**Wichita-Sedgwick County Metropolitan Area Planning Department**

December 20, 2007

Re: **BZA2007-73**: Zoning Adjustment to reduce the parking requirement from 36 to 29 spaces, in LI zoning, generally located east of Meridian and south of Esther (1819 S Meridian).

**SITE PLAN**

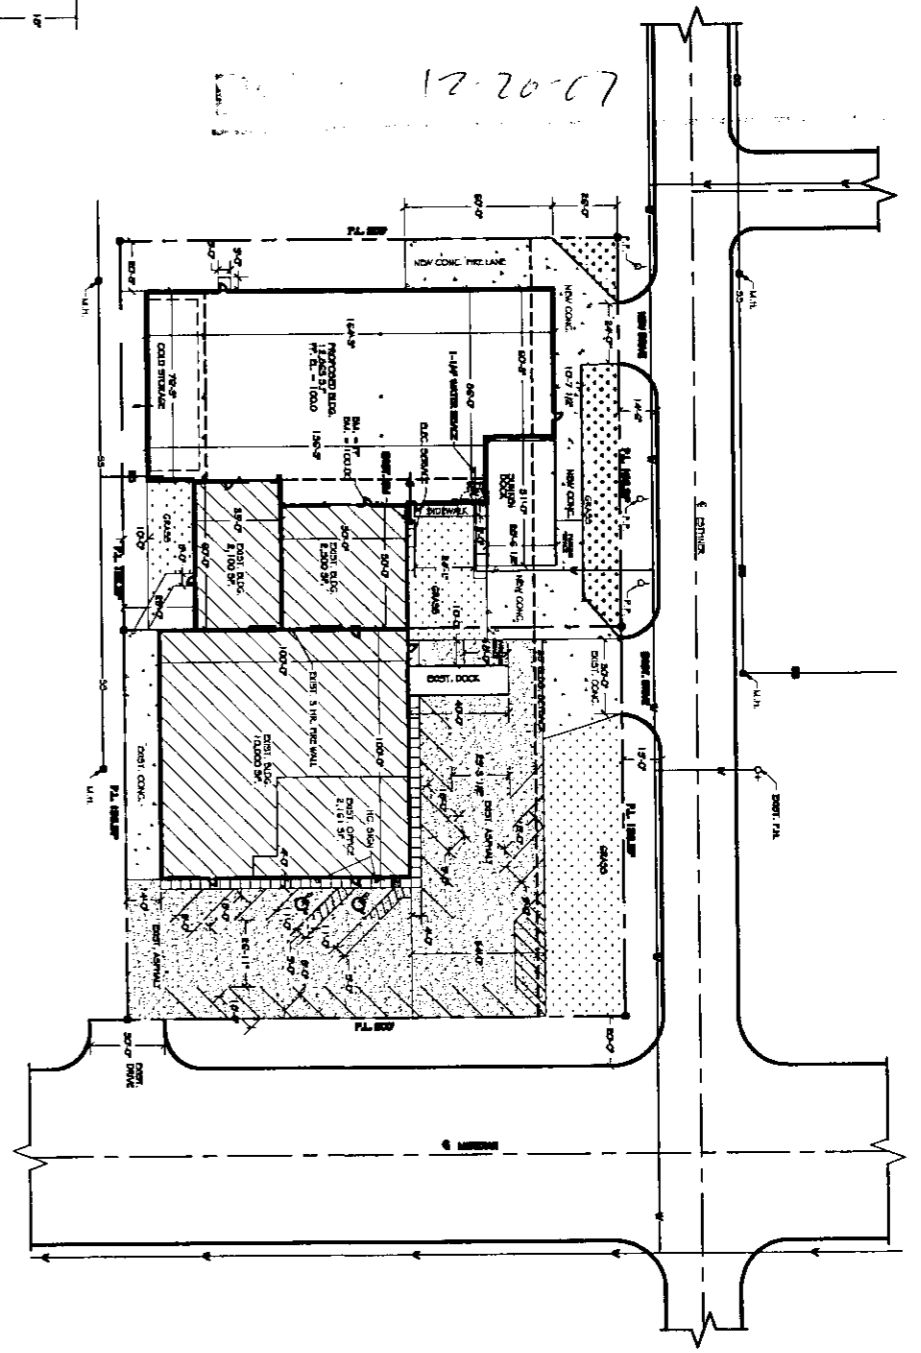
We have reviewed your Zoning Adjustment request to reduce the parking requirement on the above-referenced property. From reviewing your application we understand that you propose to expand the manufacturing facility on the site by 12,865 square feet. Your plan indicates 29 parking spaces, a 20% reduction of the 36 spaces required by the Unified Zoning Code (UZC).

Our signatures below indicate that an administrative adjustment to reduce parking by 20%, from 36 to 29 spaces is hereby granted for the aforementioned property subject to the following conditions:

- 1) The site shall be developed in general conformance with the approved site plan.
- 2) All other standards of the Unified Zoning Code shall be met, unless an additional adjustment or variance is approved.
- 3) The parking area shall be paved and marked.
- 4) If the Zoning Administrator finds that there is a violation of any of the conditions of the Zoning Adjustment, the Zoning Administrator, in addition to enforcing the other remedies set forth in the Unified Zoning Code, may, with the concurrence of the Planning Director, declare the Zoning Adjustment null and void.
